Construction and Demonstration of a Prototype Mobile Microreactor

CONSTRUCTION AND DEMONSTRATION OF A PROTOTYPE MOBILE MICROREACTOR ENVIRONMENTAL IMPACT STATEMENT

Volume 2 Comment Response Document

Final | February 2022

Figure 1. INL Radionuclide Airborne Releases, curies, from 1991 to 2018. Source: Idahoener.com

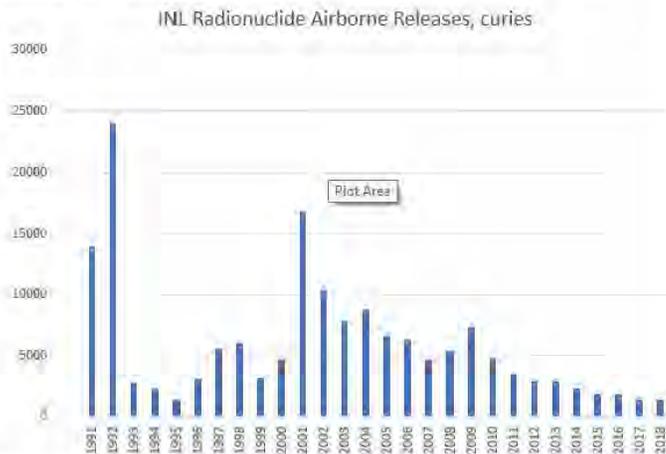
There is a general downward trend in the curie amounts of radionuclides over the last ten years; however, **the releases over the last twenty years have generally been higher than the releases during the 1990s**, see Figure 1. The DOE isn’t about to discuss the increasing radionuclide releases that commenced in 2001.

Figure 2. Department of Energy estimated annual effective whole-body dose in millirem from INL airborne releases. Source: Idahoeser.com

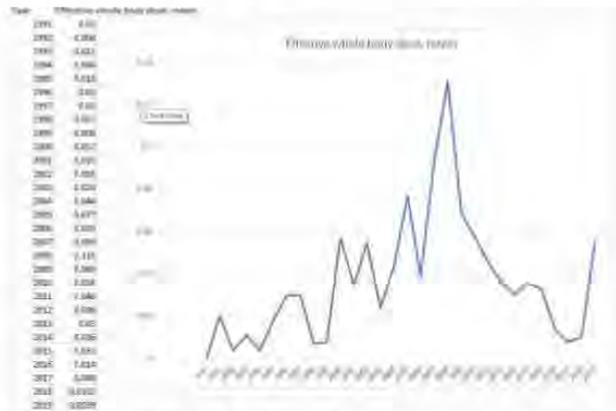
As you can see in Figure 2, the radiation doses from the Idaho National Laboratory from 2000 to 2019 are generally higher than for the 1990s. **And the radiation dose trend over the last few years is increasing, not decreasing.** This is without accounting for ingestion of radioactive animal tissue, which the draft EIS does discuss, but I have not included here. The draft EIS asserts that water we drink here, which sporadically includes high levels of radionuclides such as tritium and other man-made radionuclides, don't come from the INL and so they don't add these to the radiation dose. The dose from radioactively contaminated food and water not included in the DOE's dose estimates actually dwarf the annual radiation dose estimates.

Figure 3. Ratio of the revised Federal Guidance Report (FGR) 13 thyroid dose conversion factors (DCFs) to the original Department of Energy (HUDFACT.dat) thyroid DCF for radionuclides having the largest increases. (PNNL-22827)

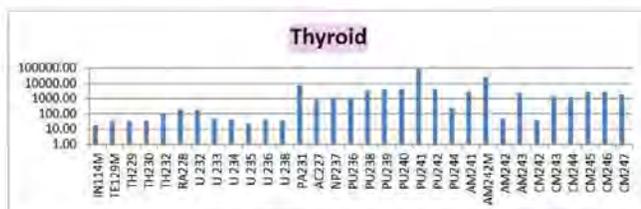
The radionuclides in Figure 3 include thorium, uranium and uranium decay progeny, plutonium, curium and americium. The thyroid cancer incidence rate increases for plutonium-238, plutonium-239, plutonium-240, plutonium-241 and americium-241 is over 1000.

Figure 4. Americium-241, plutonium-238 and other actinides released by the INL between 2001 and 2018.

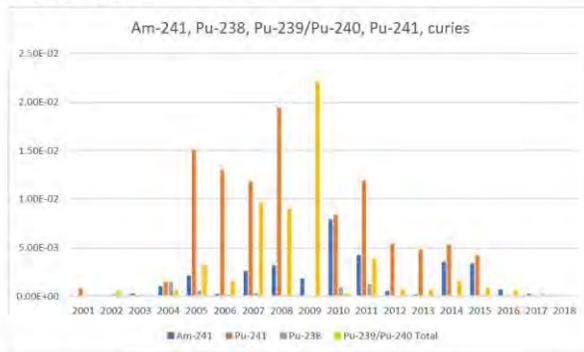
The Draft EIS must include not the deceptive look at five years of estimated effective whole-body doses from INL's airborne waste effluents, it must include the trending of the releases of americium, plutonium and iodine releases from the INL. Figure ?? shows the plutonium and americium-241 releases from the Idaho National Laboratory between 2001 and 2017 based on Department of Energy environmental monitoring reports.⁴¹ The State of Idaho DEQ does not display, report or trend any data before 2013. ...can anyone guess why? The huge releases from the INL between 2004 and 2013 are shocking and certainly would not fit well with a tourist brochure for visiting Idaho.

Figure 5. Iodine-129 and iodine-131 released from the INL between 1973 and 2018.

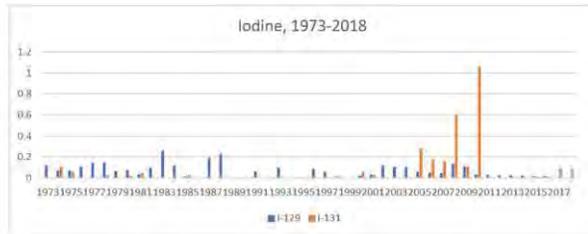
Figure 5 shows the iodine-129 and iodine-131 releases between 1973 and 2017, in curies. The State of Idaho DEQ went from displaying all of their environmental monitoring reports to displaying ten years of the reports, to now displaying only six years of annual reports and only 4 years of quarterly data reports from 2013 to 2018. **Again, here you can see why the Idaho DEQ didn't want to display INL monitoring data before 2013.**

The plutonium and americium-241 and the iodine-129 and iodine-131 are not the only radionuclides with elevated releases from the INL. But these radionuclides might have influenced the elevated thyroid cancers in Bonneville County reported for 2013 to 2017, yet the Department of Energy continued ignoring the thyroid organ doses.
